MFN 10-098 Docket No. 52-010

Subject: **Transmittal of ESBWR Tier 2, Appendix 3K and Chapter 10 DCD Markups Related to GEH Internal Corrective Action**

Document Improvements and Specific Changes to

Chapter 10, Figures 10.1-2a, 10.1-2b and 10.3-2

Figure 10.1-2a. Rated Heat Balance (SI Units)~~[RC52]~~

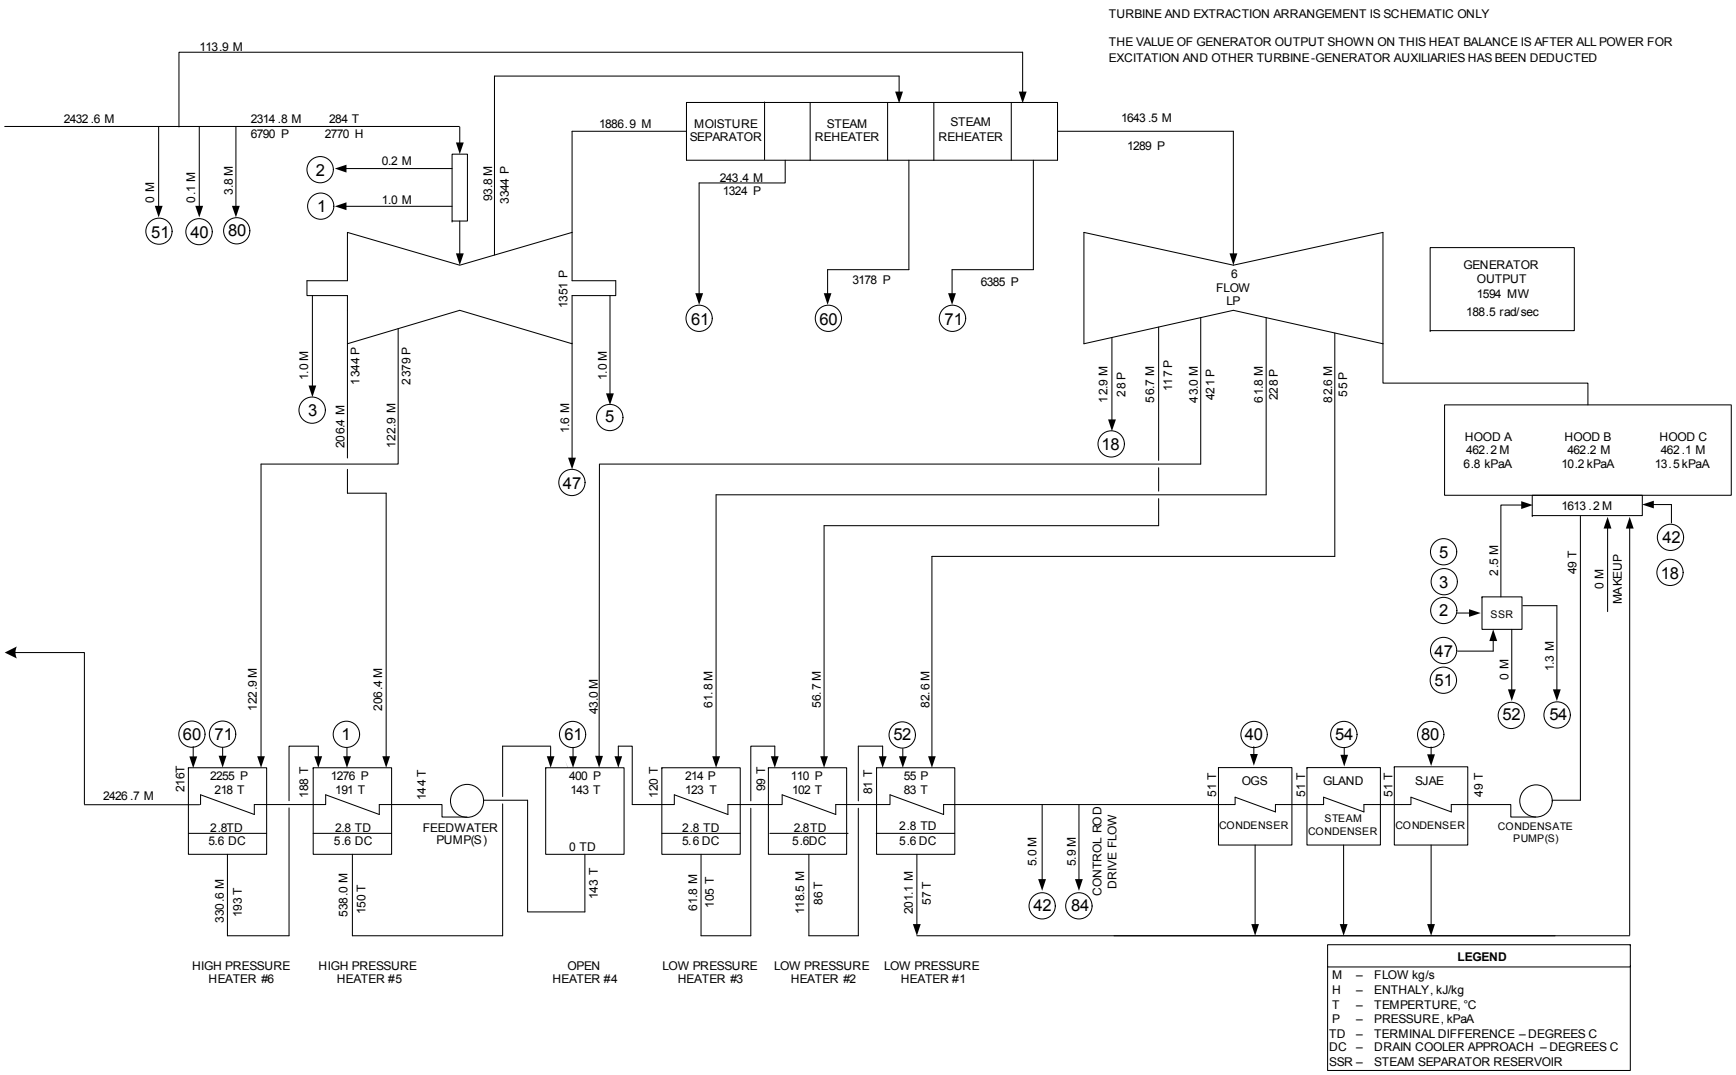
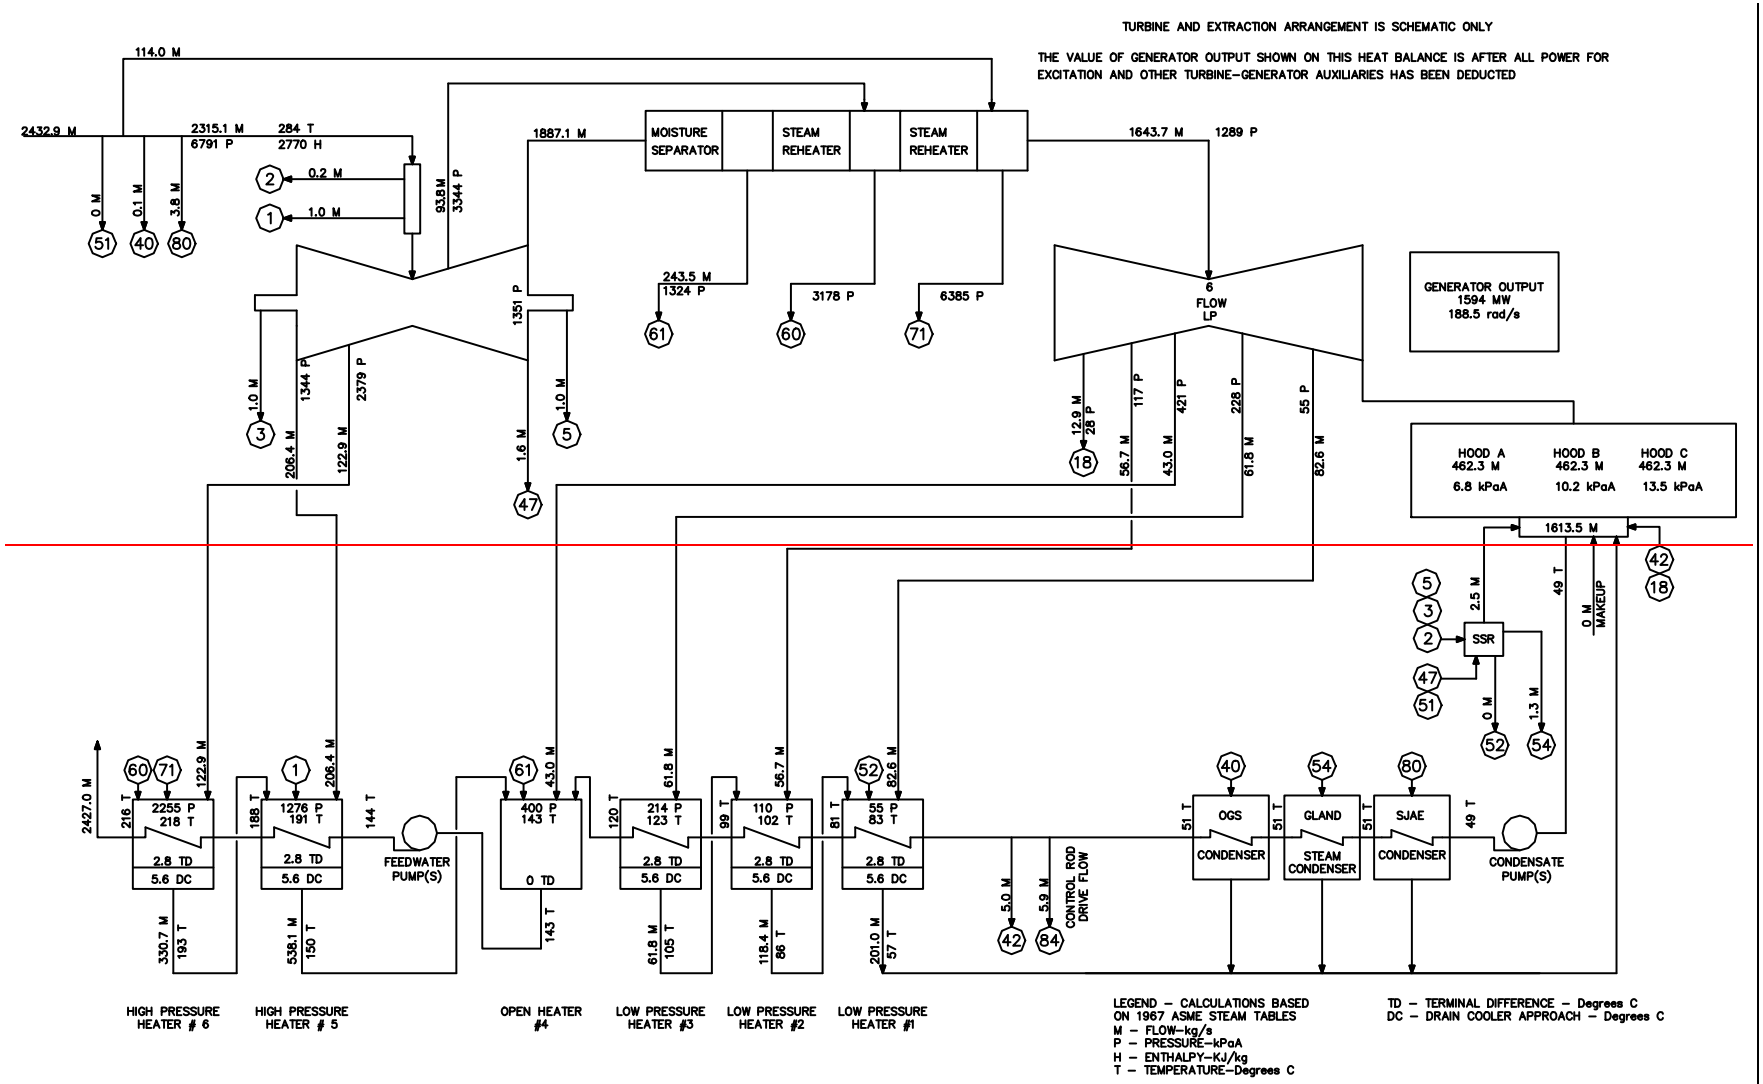
Chapter 10, Figures 10.1-2a and 10.1-2b were revised with the correct steam flow from the RPV. Figures 10.1-2a and 10.1-2b did not match the correct RPV steam flow in DCD Chapter 1, Figure 1.1-3b. The revised Figures 10.1-2a and 10.1-2b are now consistent with Figure 1.1-3b.

Figure 10.3-2. Main Turbine System

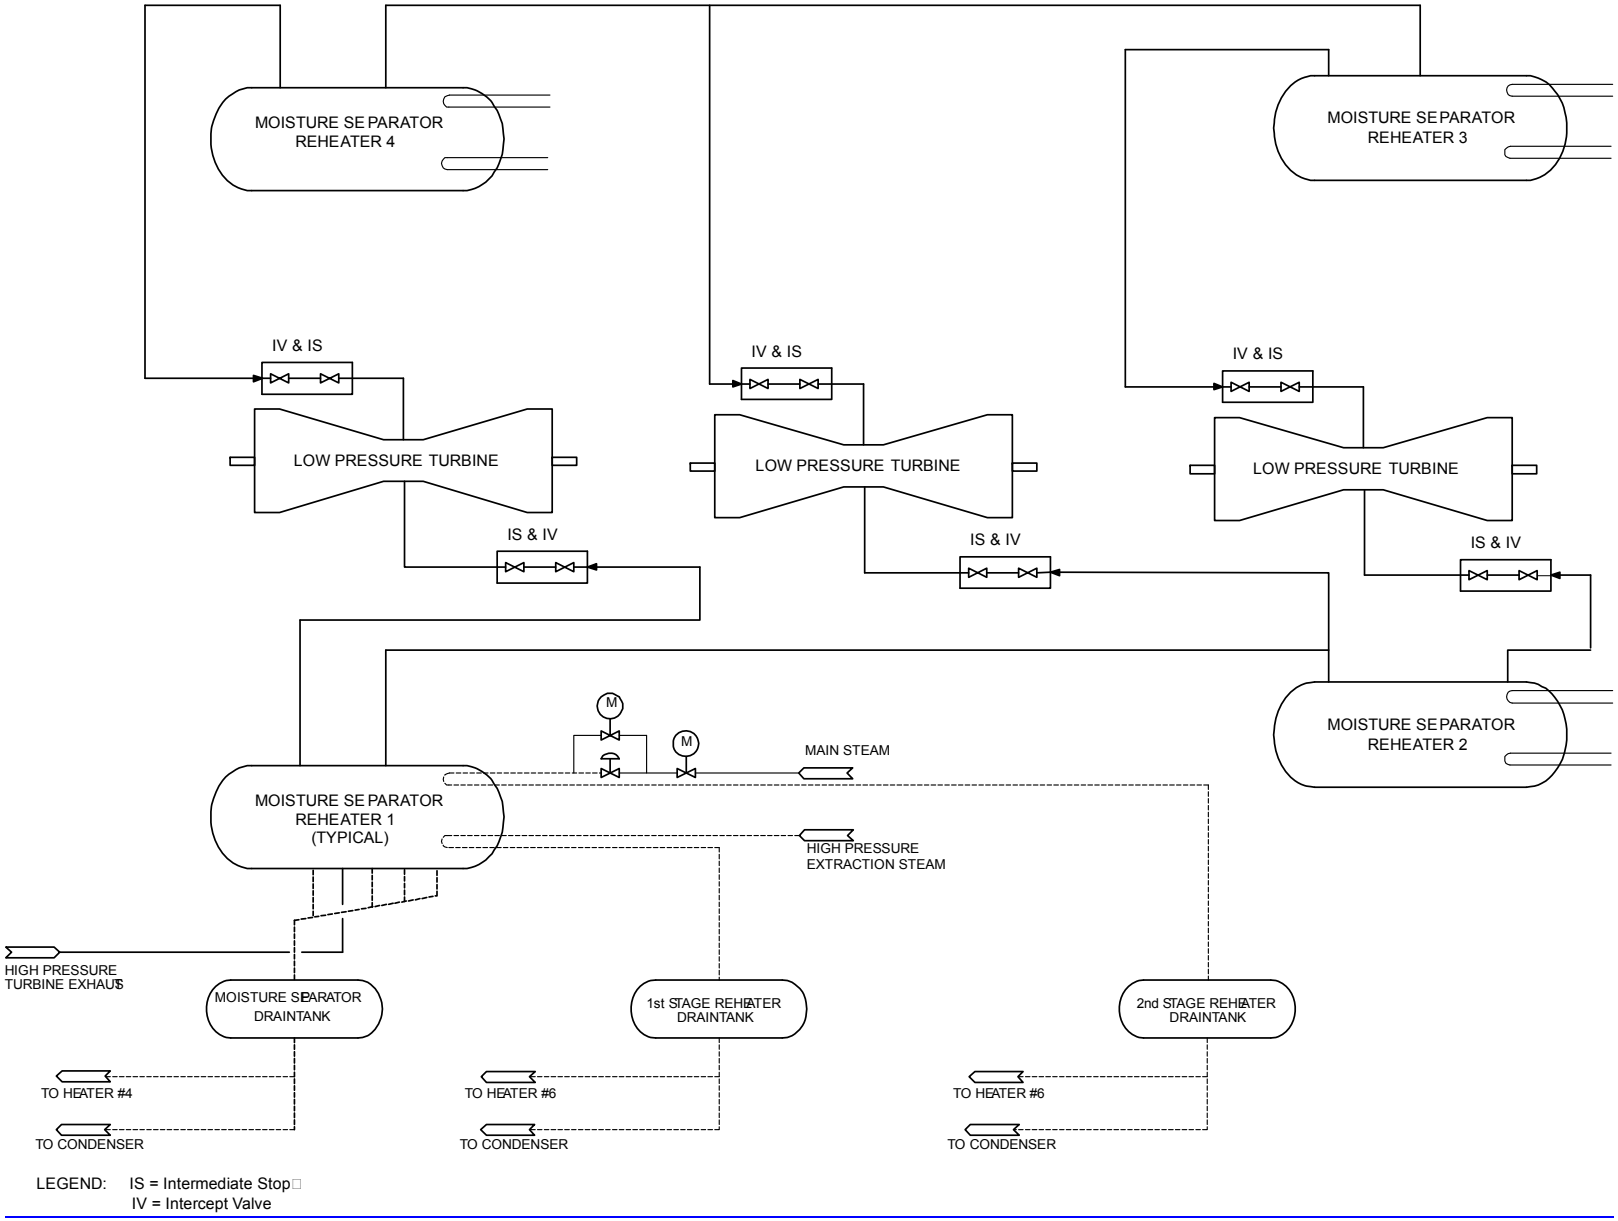
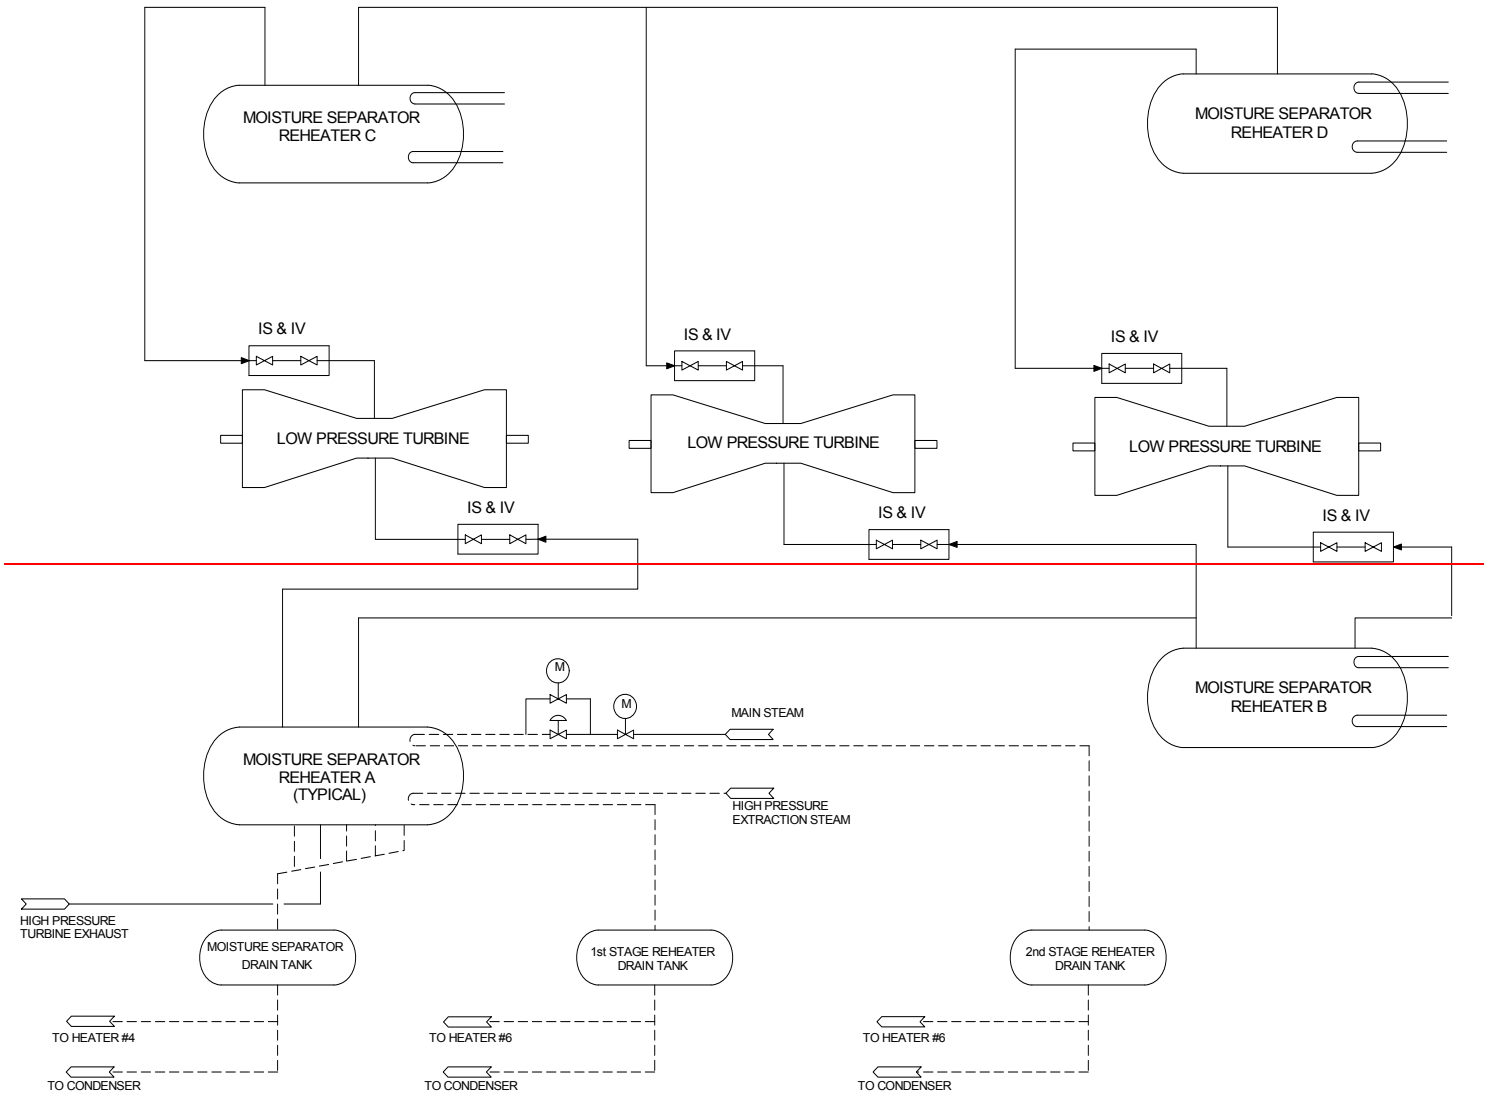
Chapter 10, Figure 10.3-2 was change to match Fig 10.4-7a in the numbering (1, 2, 3, 4) of the MSRs verses the "letters" (A, B, C, D) used on the old Fig 10.3-2. In addition, the three "IS & IV" under the LP turbines were changed to “IV & IS” since the nomenclature is correct on top of the LP turbines, but was backwards under the LP turbines.
